0City of Sierra Madre Agenda Report

SUBJECT: CONTINUATION OF MARCH 14, 2023, APPEAL OF PLANNING COMMISSION DECISION APPROVING A REQUEST FOR A CONDITIONAL USE PERMIT AMENDMENT AND AN ADDENDUM TO THE MITIGATED NEGATIVE DECLARATION TO UPDATE THE ALVERNO HEIGHTS ACADEMY (AHA) MASTER PLAN AT 200 NORTH MICHILLINDA AVENUE

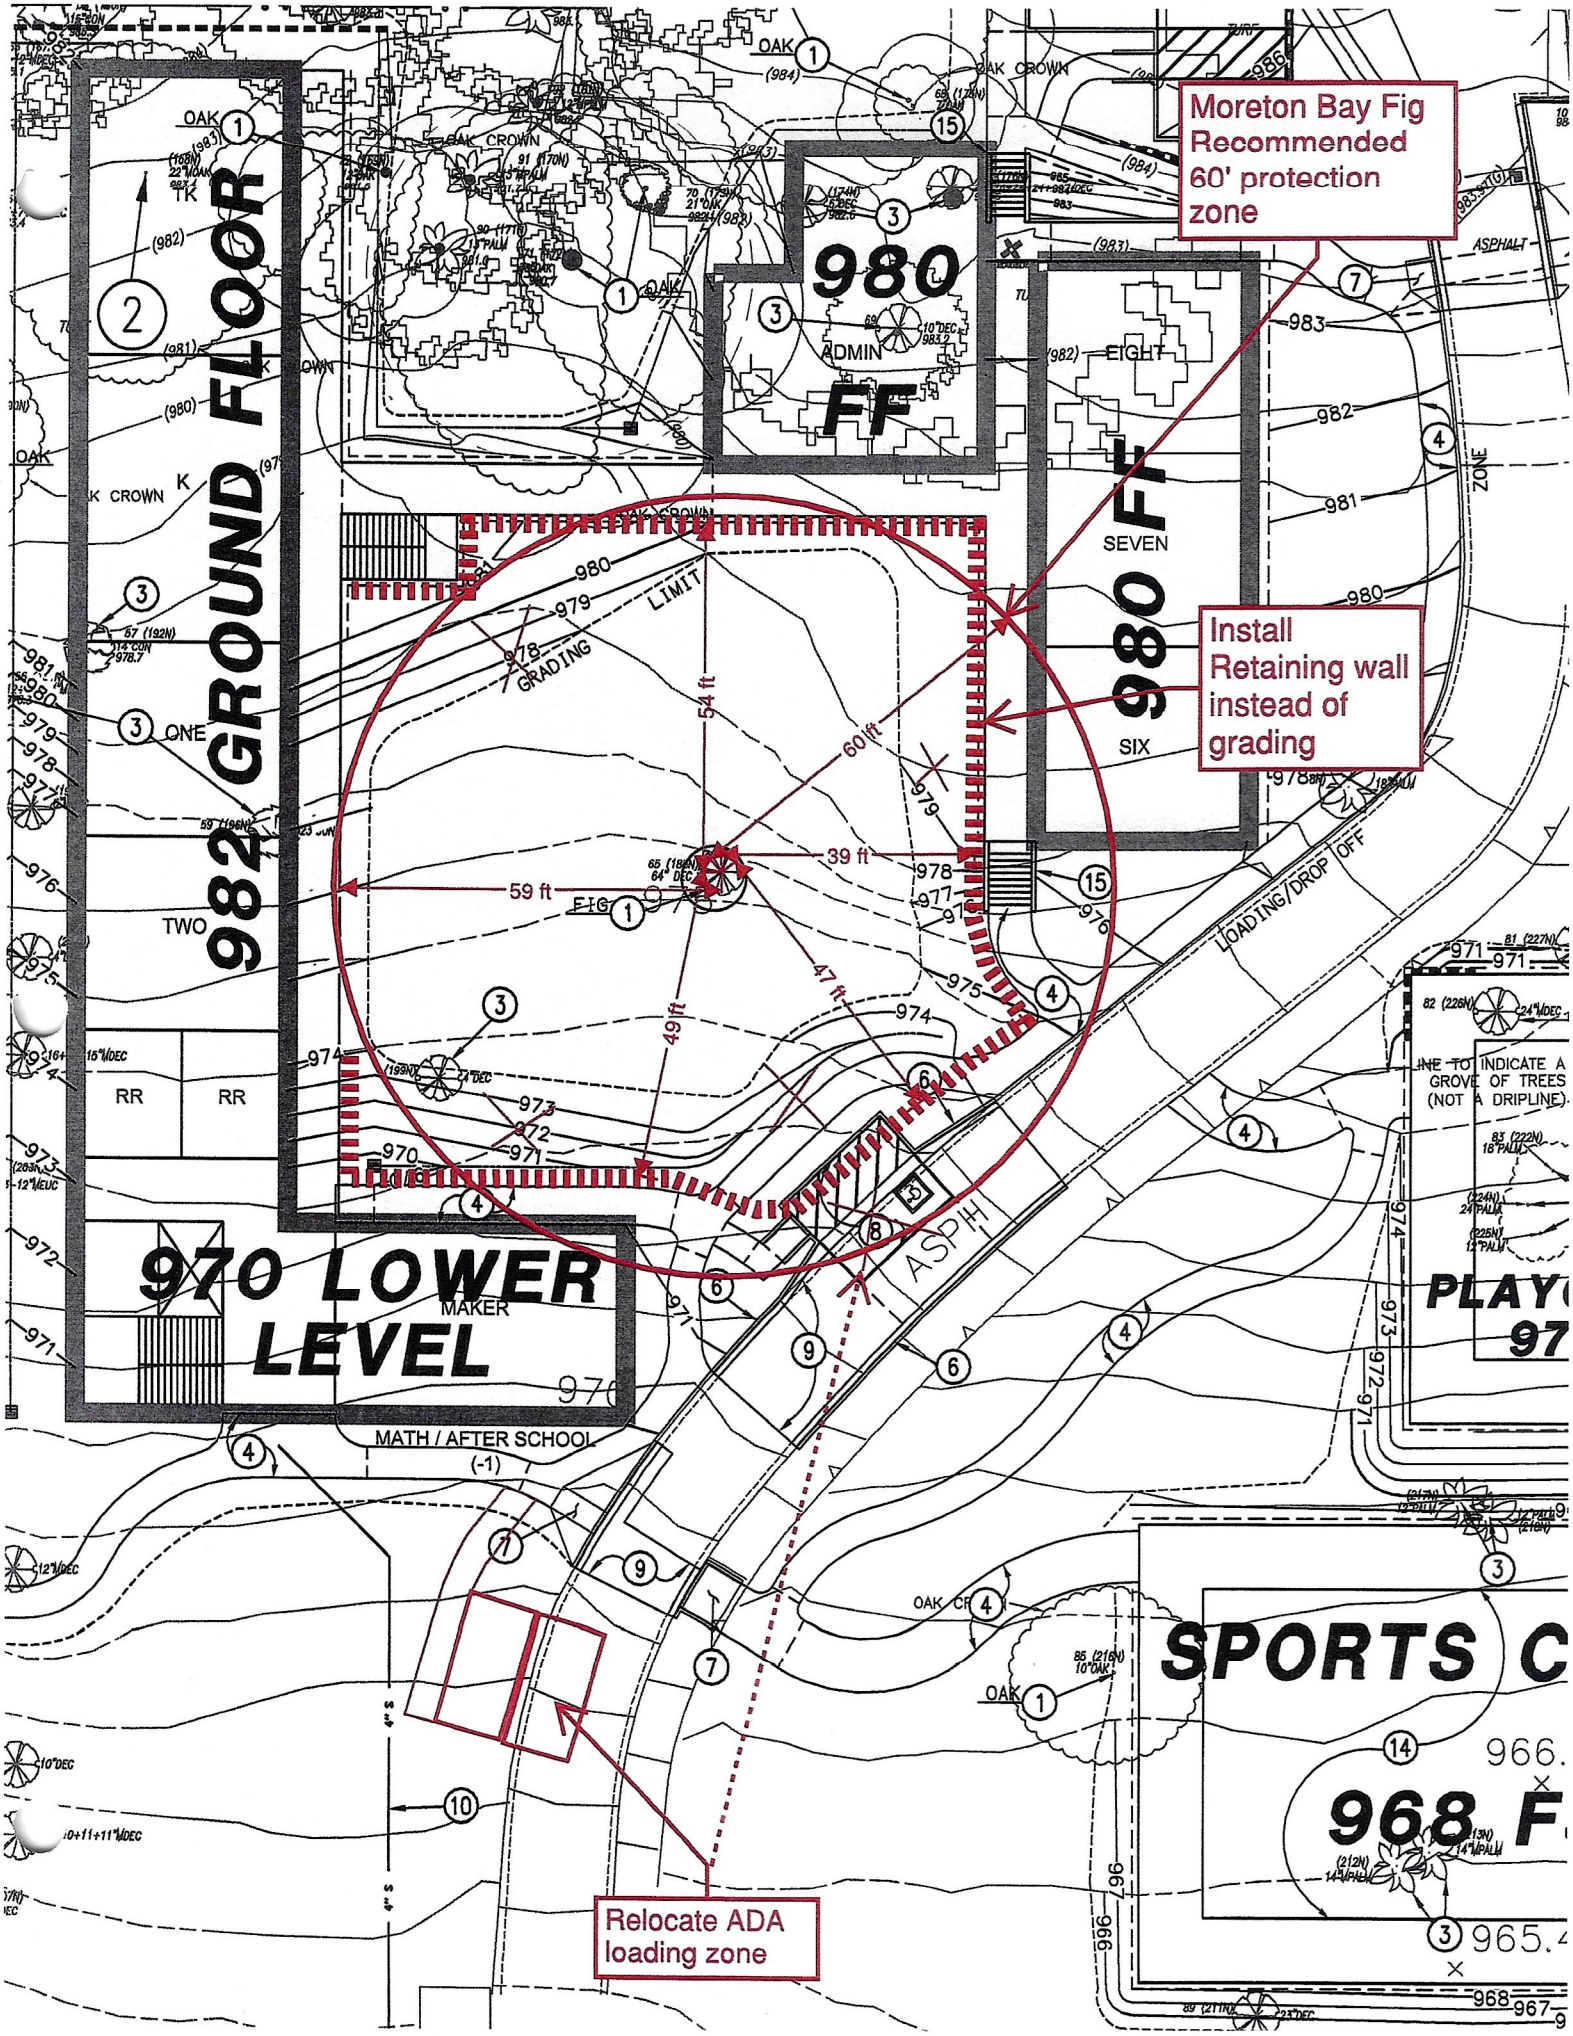
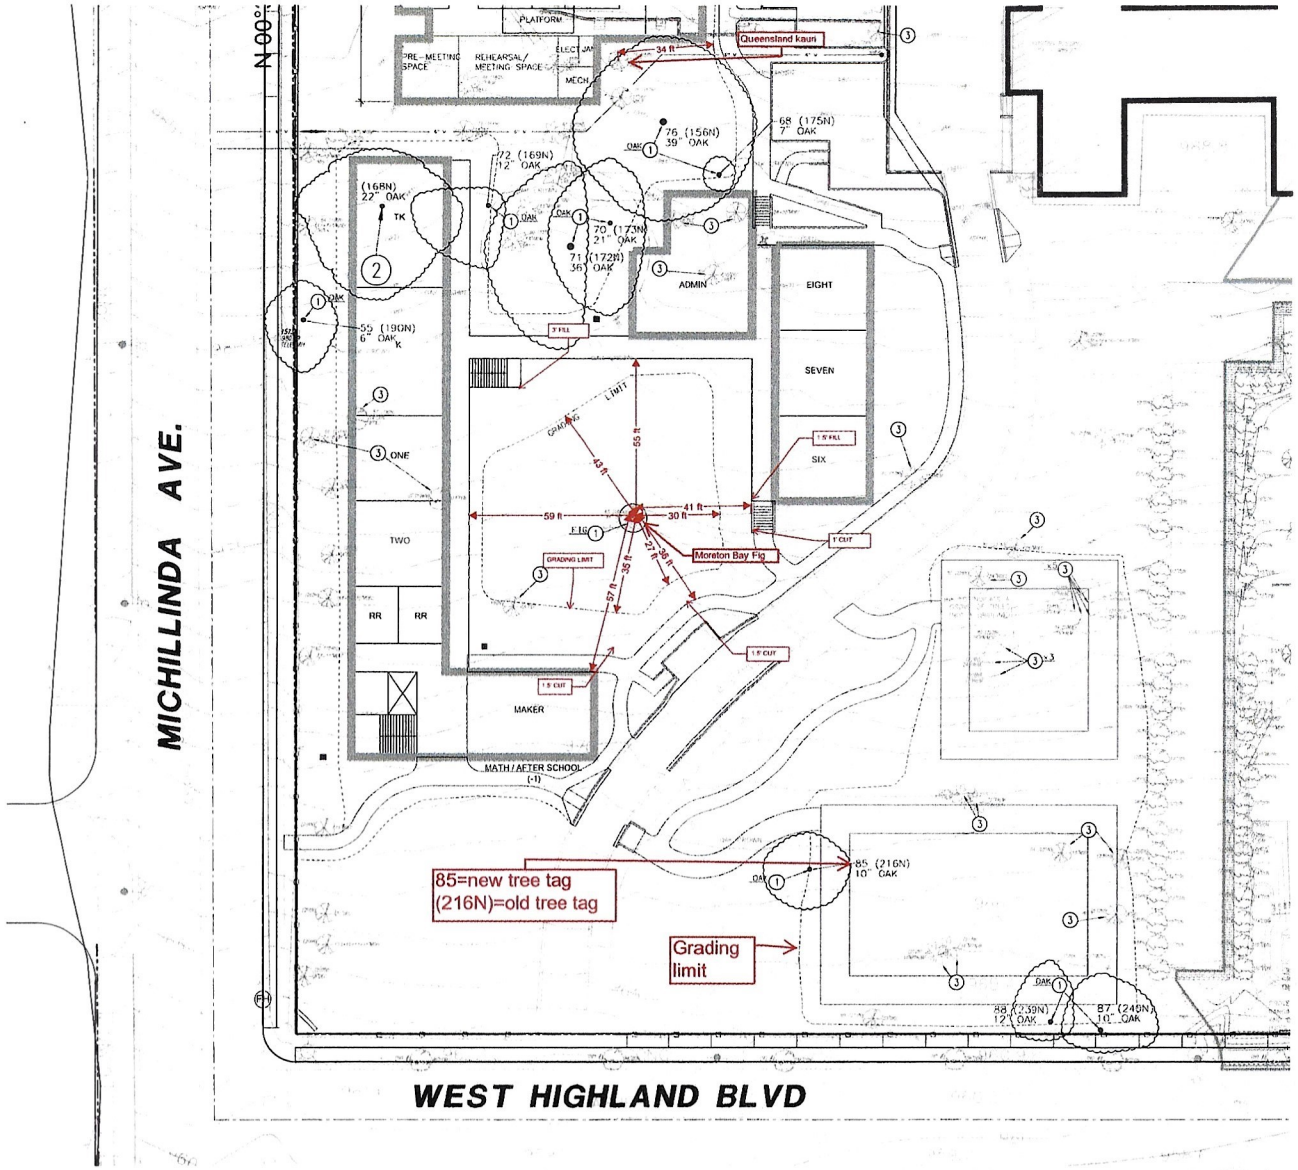
The marked up attached exhibit shows the proposed revisions to the grading plan. The Arborist stated that revised grading will reduce the impacts to the Moreton Bay Fig, but would not eliminate the impacts. He reiterated that any construction within 60' of the tree will have impacts to the health of the tree.

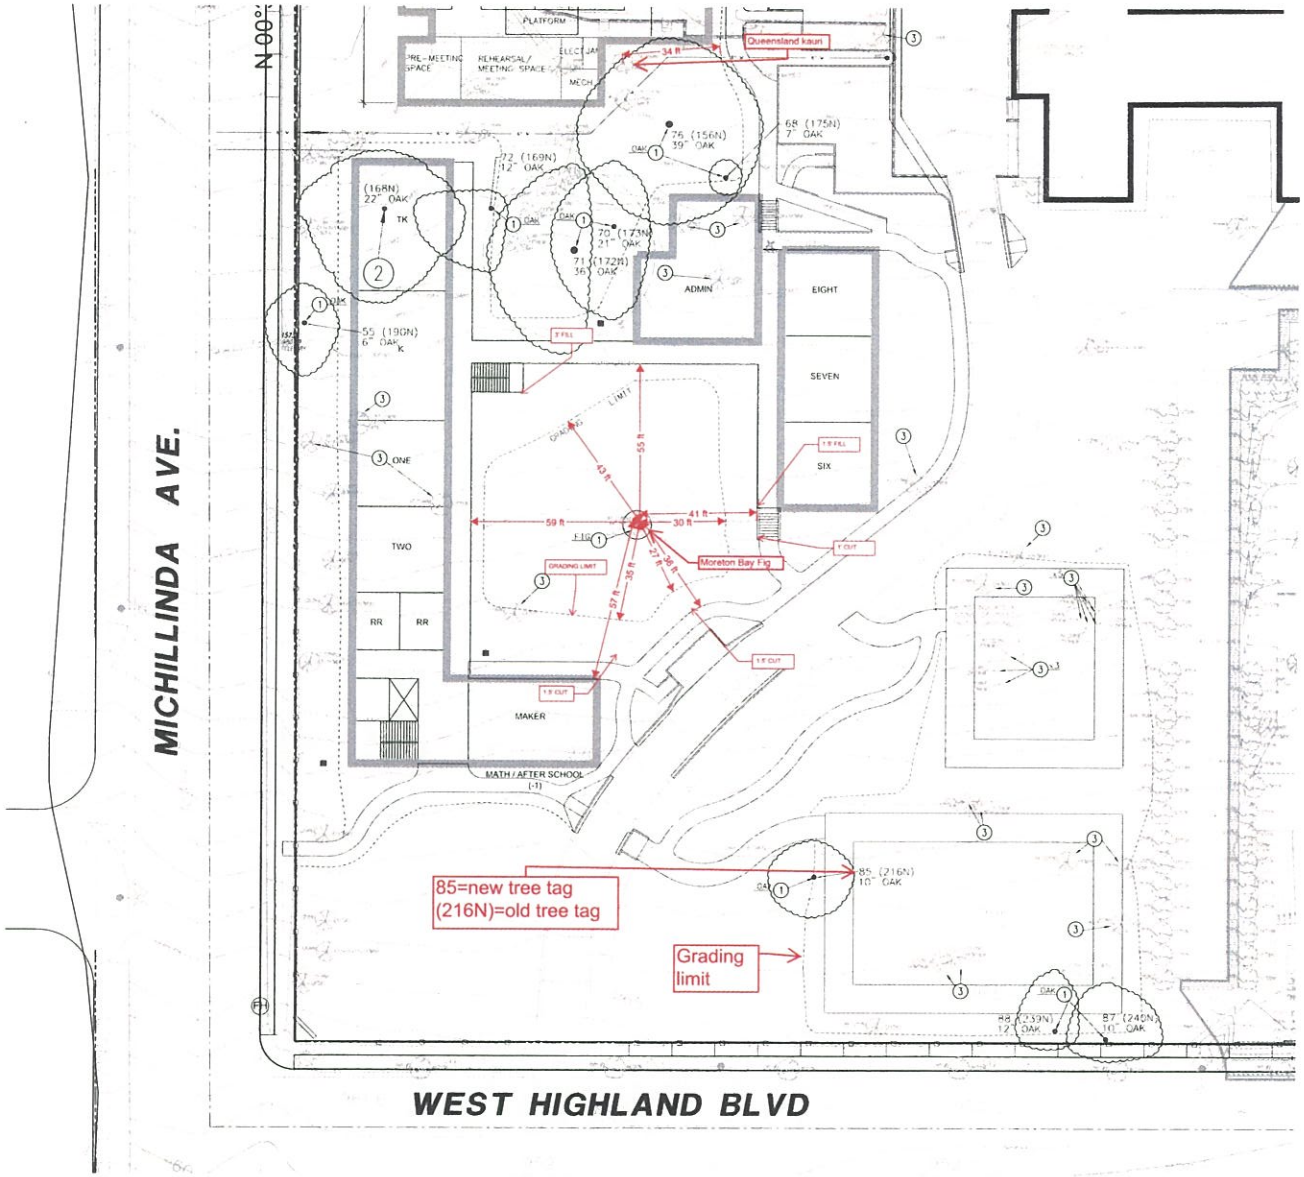
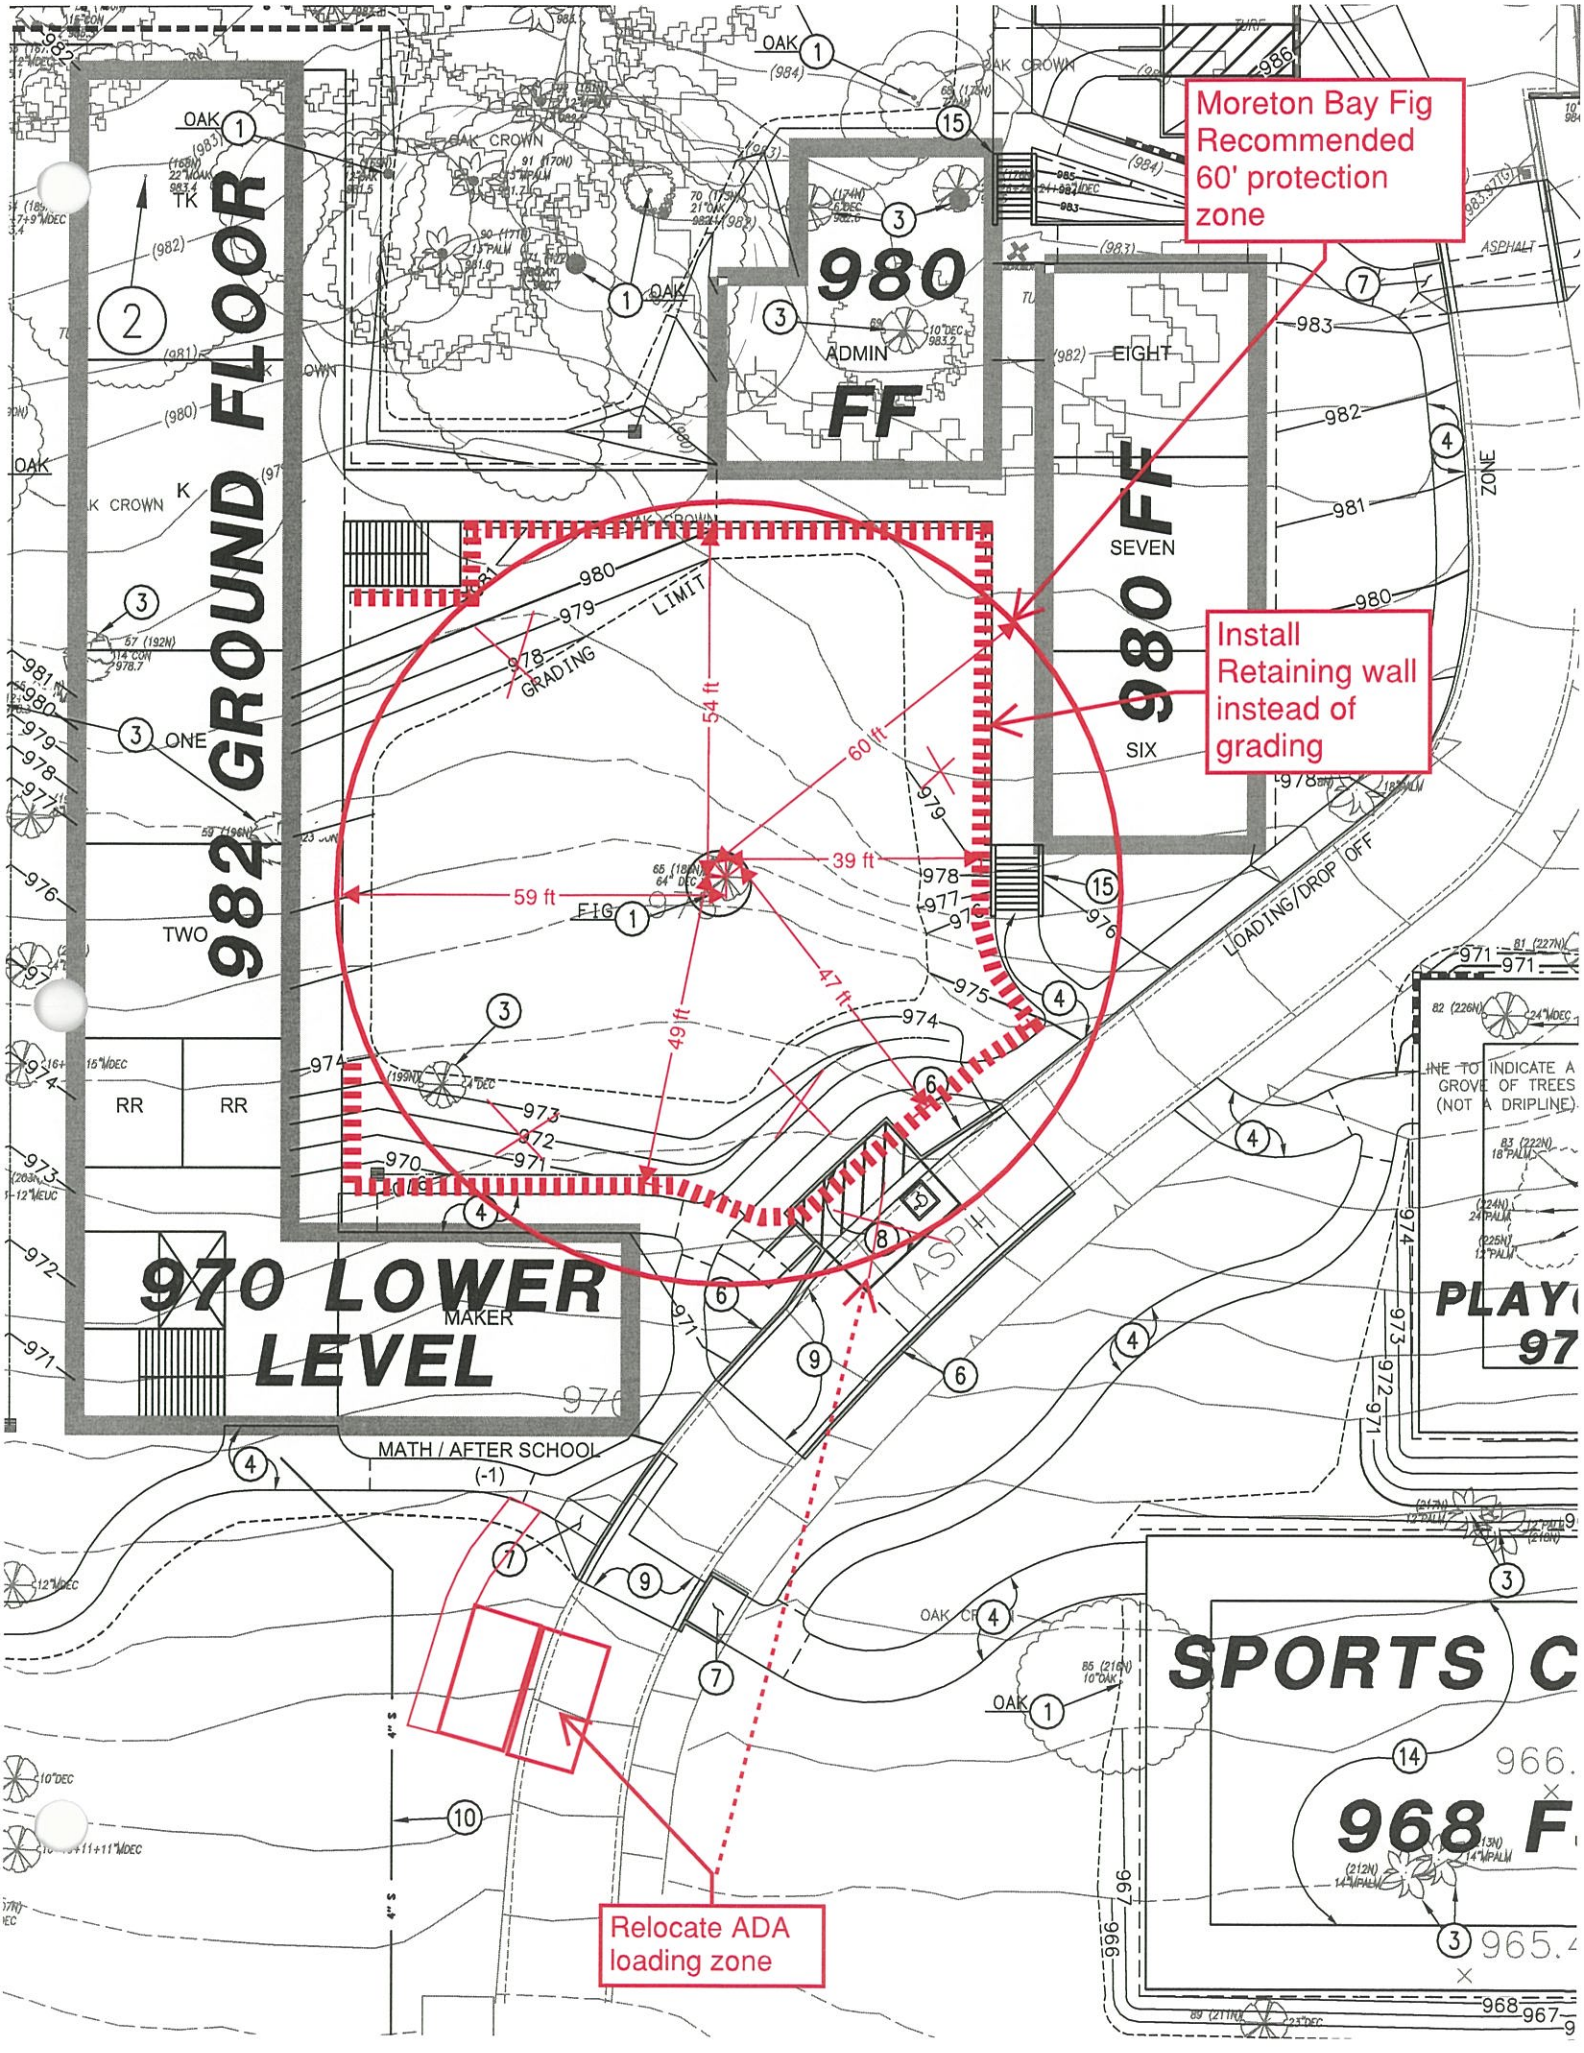
The marked up attached exhibit shows the proposed revisions to the grading plan. The Arborist stated that revised grading will reduce the impacts to the Moreton Bay Fig, but would not eliminate the impacts. He reiterated that any construction within 60' of the tree will have impacts to the health of the tree.

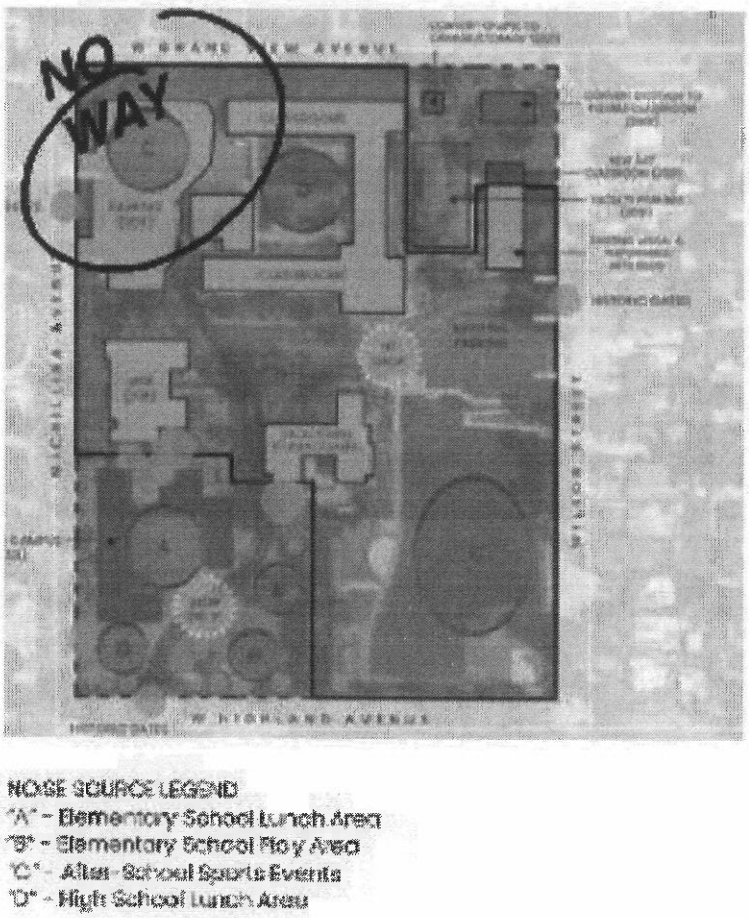
Michillinda parking lot for sports activities **are not expected to generate average or instantaneous noise levels that exceed the existing ambient noise levels at the nearby homes on Grandview Avenue.**

That illustration and the "C" designation has NEVER been discussed with the neighbors *at any expansion* meeting. We did ask about the use of the parking lot. We asked when it will cease? We were told, 'it won't". Now we see, that even after the Multipurpose Building is built, AHA expects to subject us to an unreasonable and profoundly noisy use. What will prevent them for using the space for any other use if they are willing to do so with complete disregard to the impact on the neighbors and without a permit?
